# Tres Sueños Unit Twenty One

City of El Paso — City Plan Commission — 10/4/2018

**SUSU18-00082 — Major Preliminary REVISED**

- To allow a 52' ROW with 32' of pavement, 5' landscape parkway and 5' sidewalk.

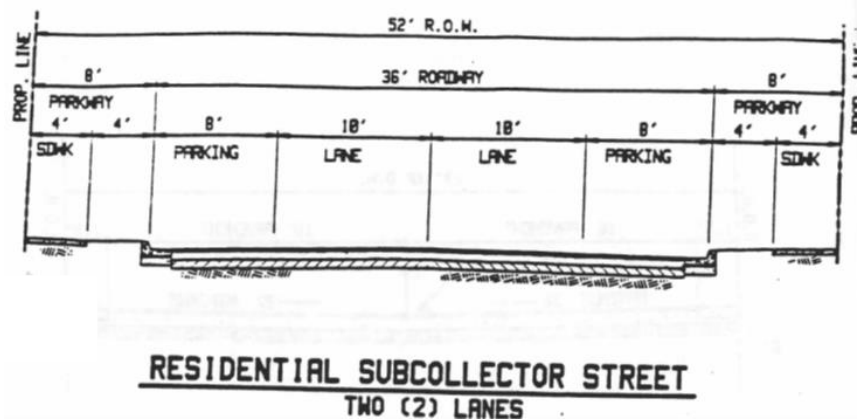
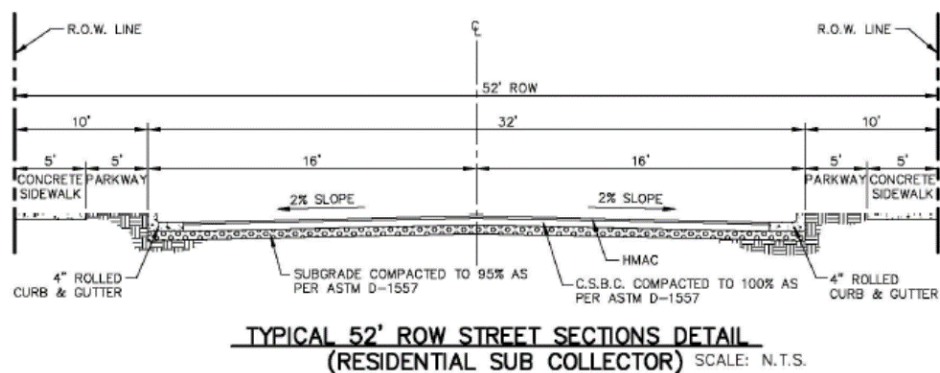
### DESCRIPTION OF ANY EXCEPTIONS, MODIFICATIONS, OR WAIVERS

The applicant does meet the following criteria under Section 19.04.170.A2-A3 (Modifications of conditions) for requesting exceptions. The section reads as follows:

#### **Section 19.04.170.A3**

The subdivider has demonstrated an alternative method of development that will improve the aesthetic value of the subdivision while giving equal emphasis to safety, economy, tax yield, maintenance cost, response time, drainage, dedication and improvement of parkland and open space amenities, and vehicular access and pedestrian passage.

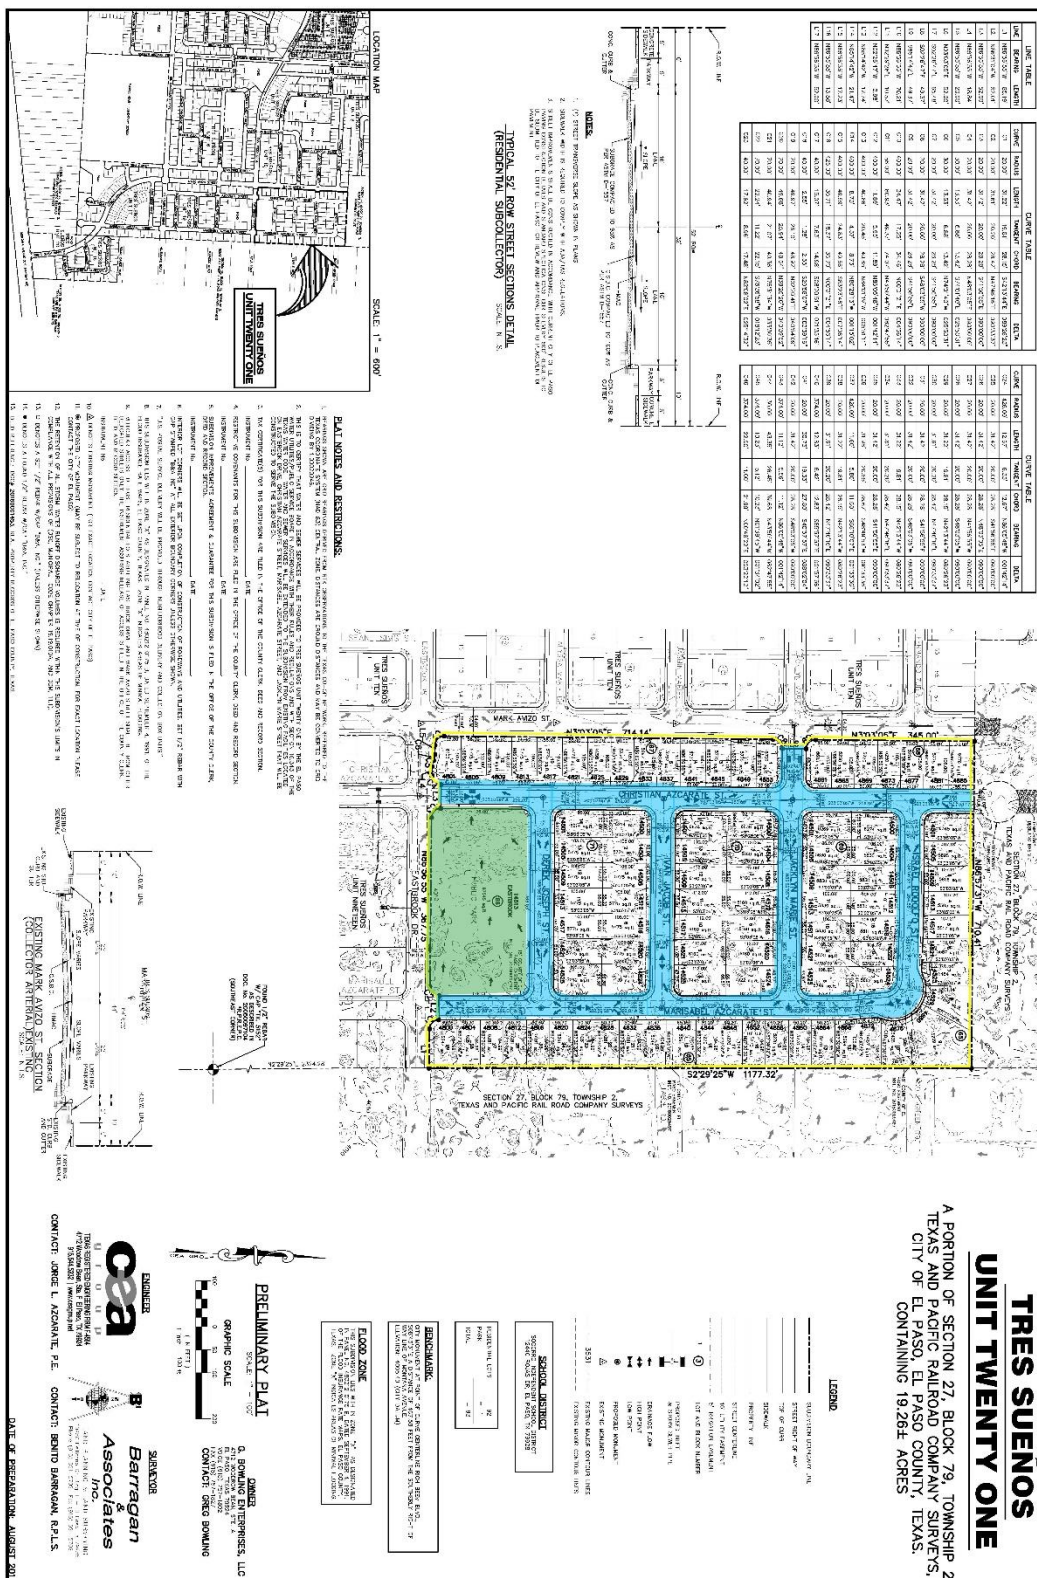
1. As per section Code 19.08.010, section D, each proposed phase of development shall have a complete drainage system.
2. Label pond and other infrastructure as existing if already built and specify any temporary protection measures.
3. At the improvement plan stage, provide protection to the property from all offsite storm-water runoff that may have an adverse impact on any improvements.
4. All drainage infrastructure within Tres Suenos Unit 19 shall be built prior to or concurrently with this subdivision.

Requested several block number changes; these revisions were sent to the applicant to address.

The County would prefer the subdivision tie into Stable Road and Boots Green Road for connectivity reasons and to avoid those streets becoming ½ mile dead-end streets that pose a public safety and welfare issue.
